ADDENDUM

Project: **Crestwood School District
Cherry Hill Baptist Church
Administration Relocation and Addition**

Date: **August 15, 2023**

Addendum Number: **#002**

Code Review Plan

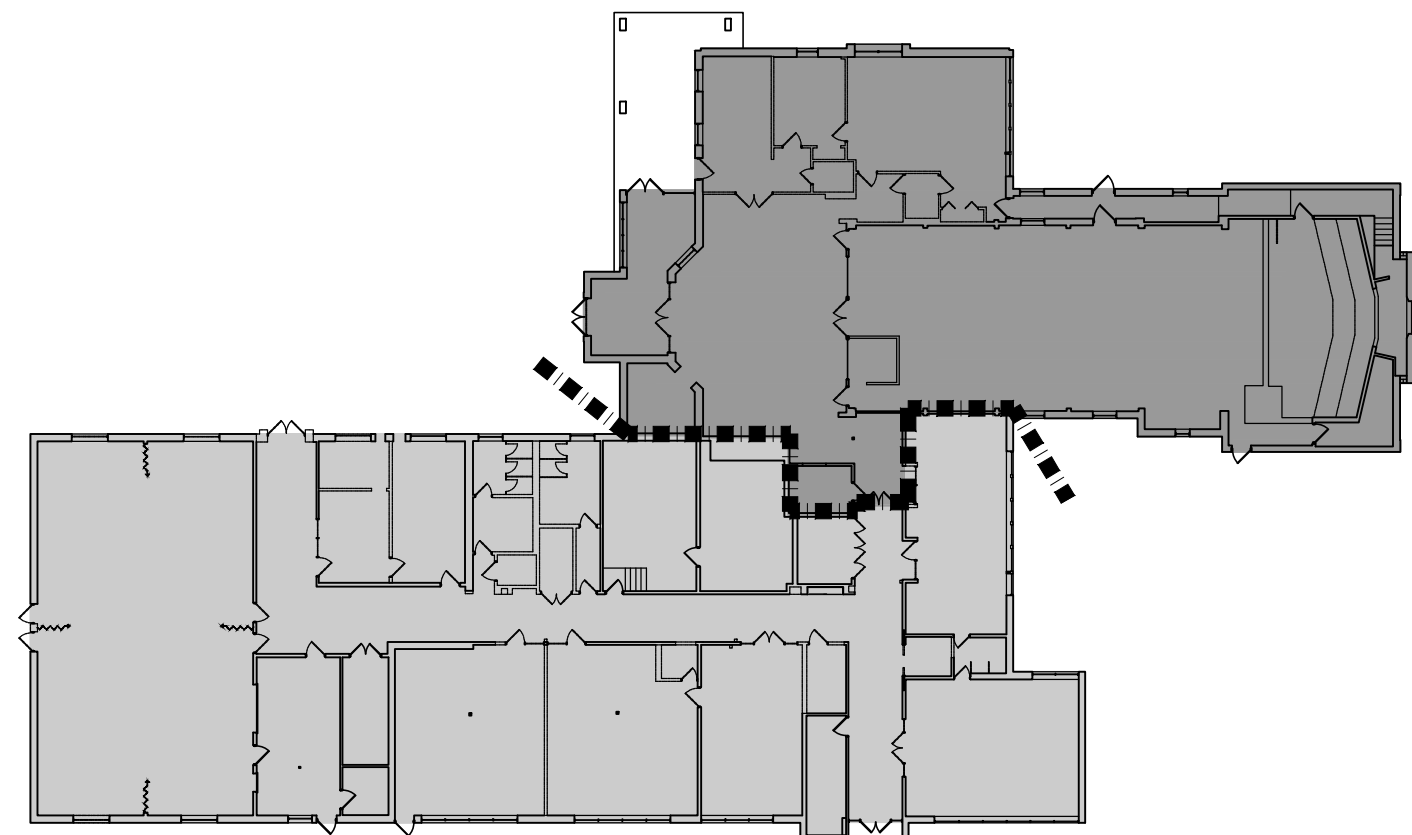
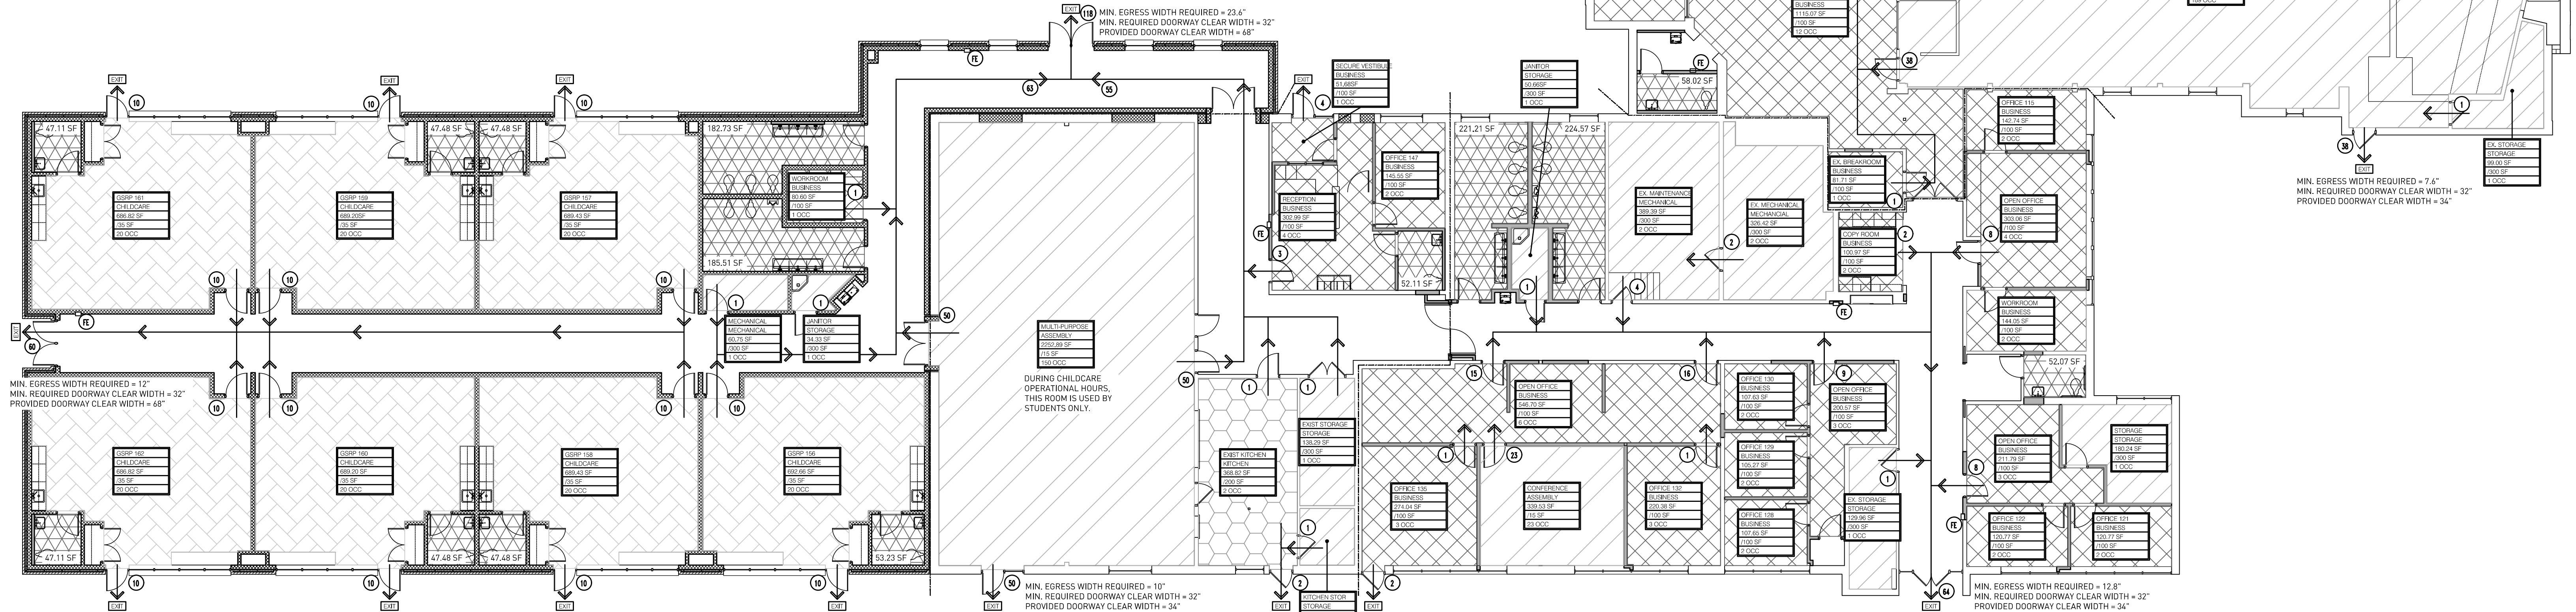
A0.01 - Code Review Plan

ADD: Sheet to drawing set

1 FOUNDATION PLAN
1/8" = 1'-0"

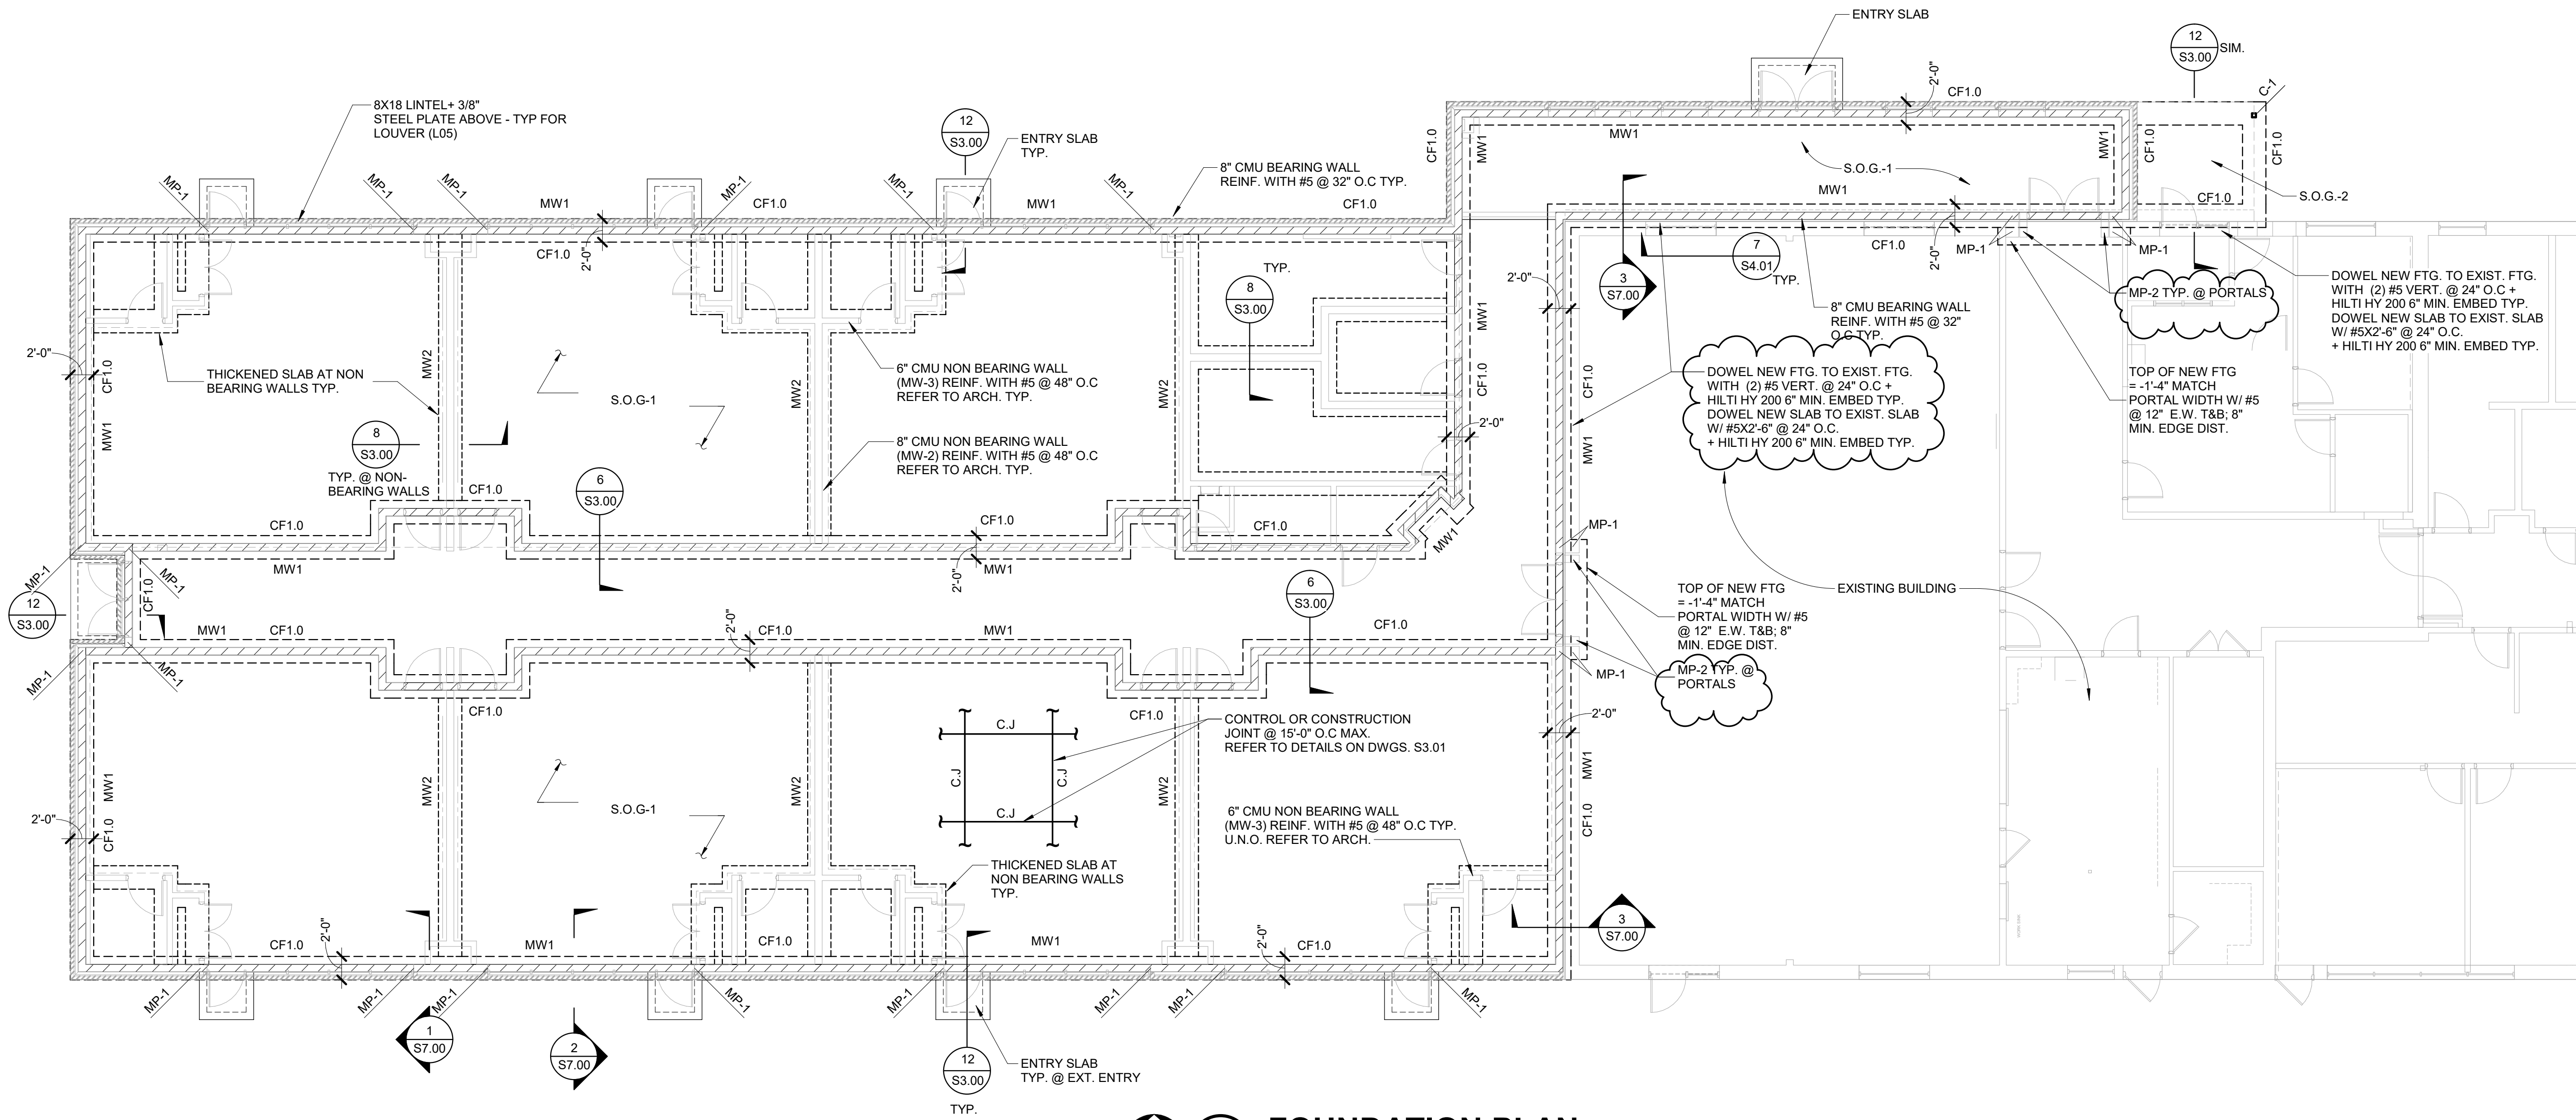
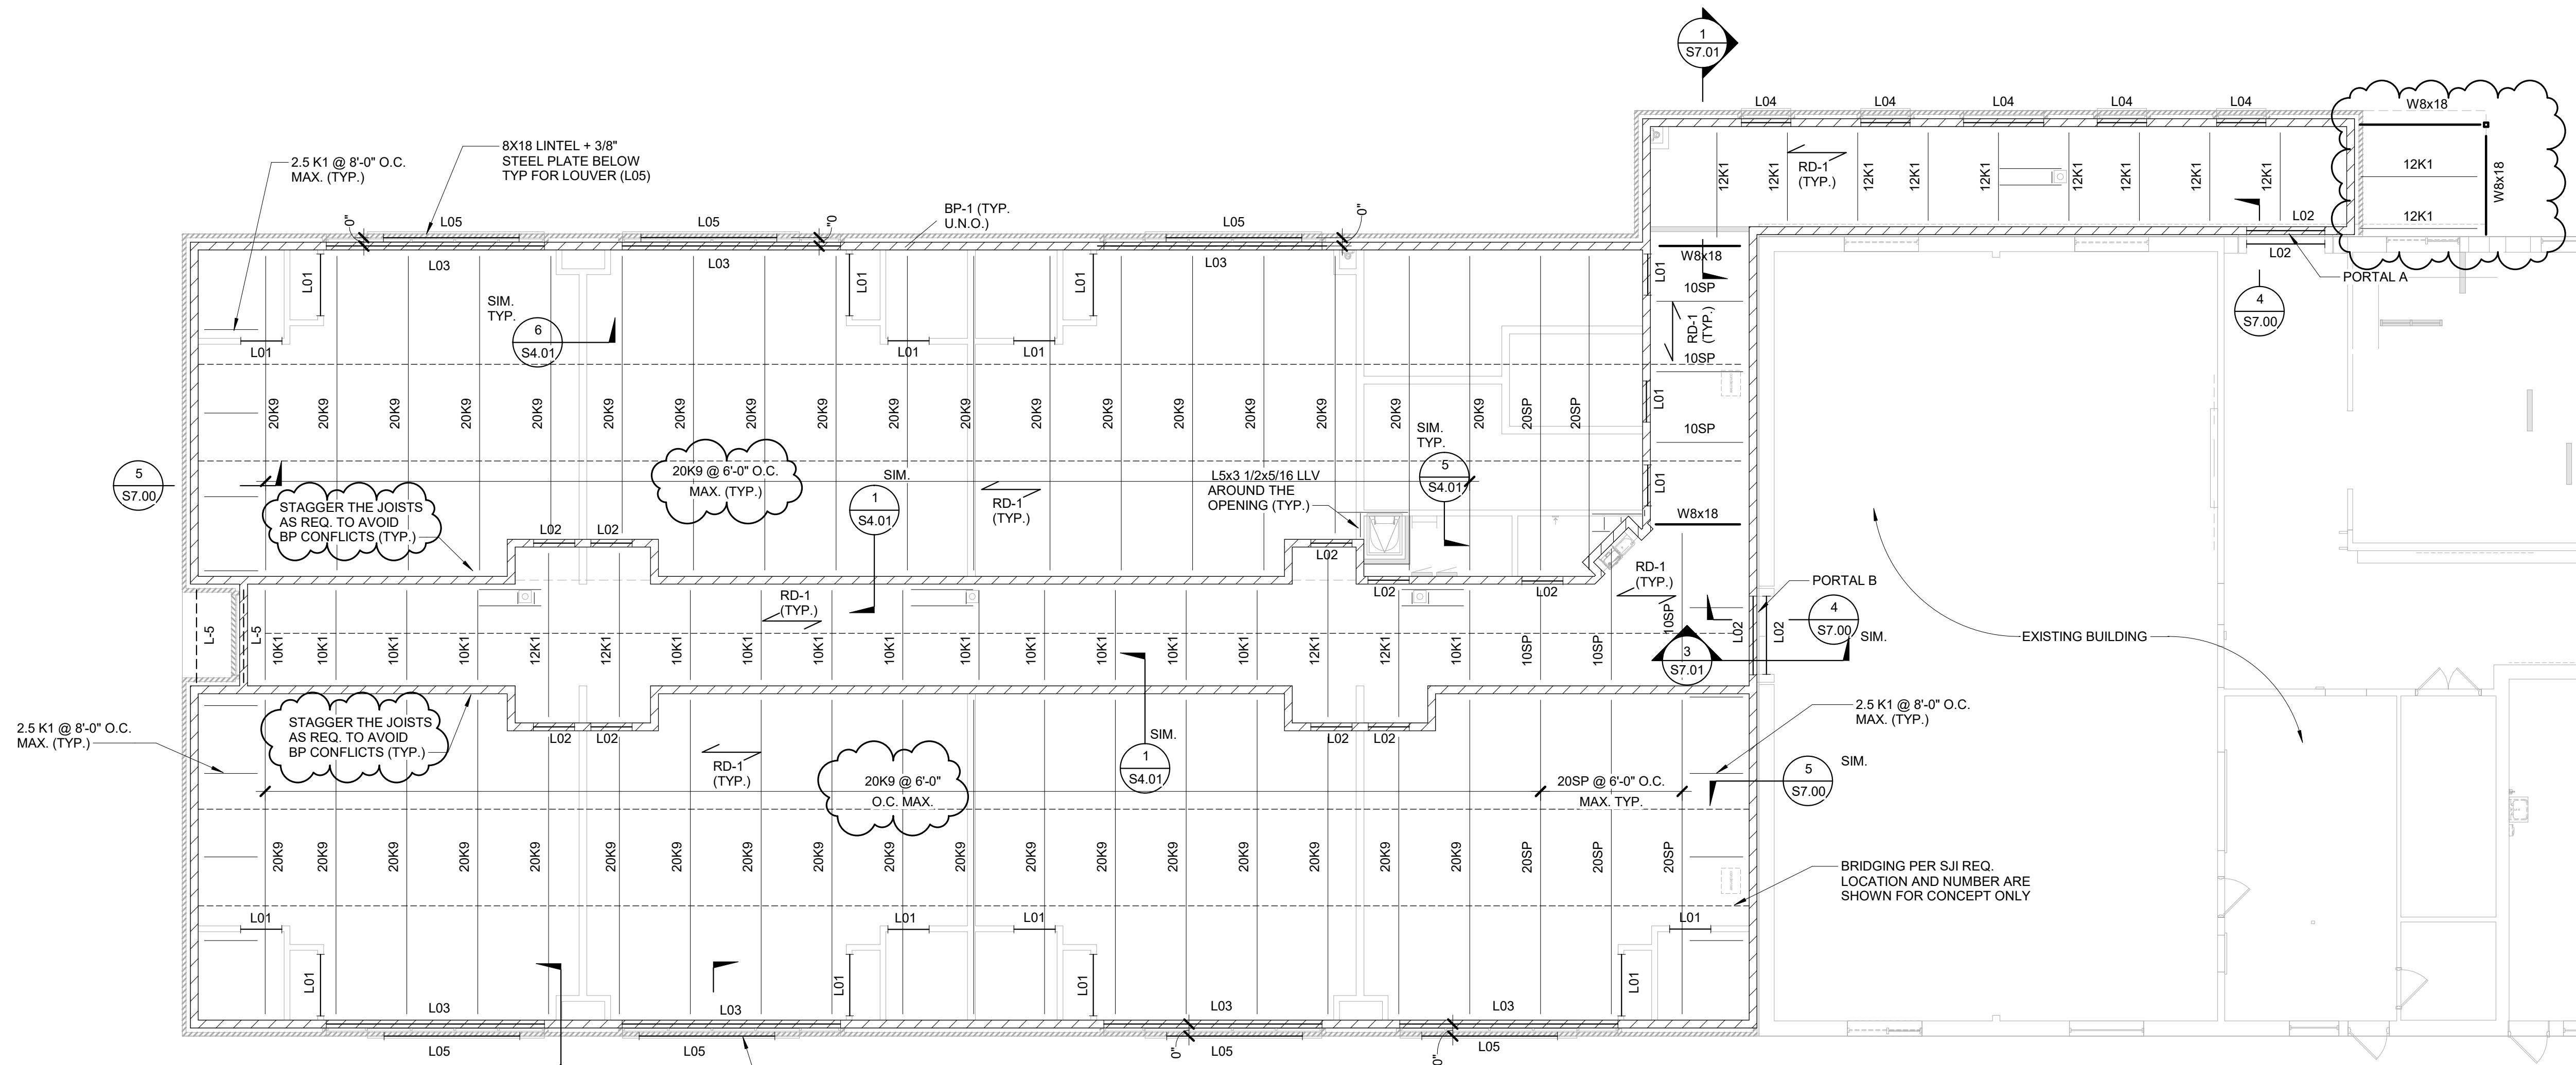
S2.10 – Foundation Plan

REVISE: Refer to clouded areas for drawing revisions.
